Title ESP 3G Flower Pot Console				Number <Doc>
Size A	Engineer SJensen	Path <Path>	Filename 3gwireharness.op	Rev 1.0.1
Date: Thursday, September 10, 2020	Sheet 1	of 1

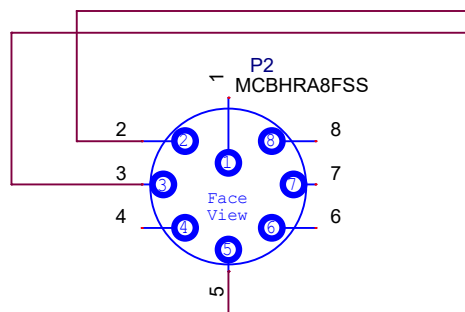
Rev 1.0.0 has wrong wire color for P2-2 and 3
 Rev 0.0.0 has TX and RX connected as contextual sensor
 Contextual Sensor Bulkhead
 1 - RTS (out)
 2 - TX (out)
 3 - RX (in)
 4 - CTS(in)
 5 - Comm. GND
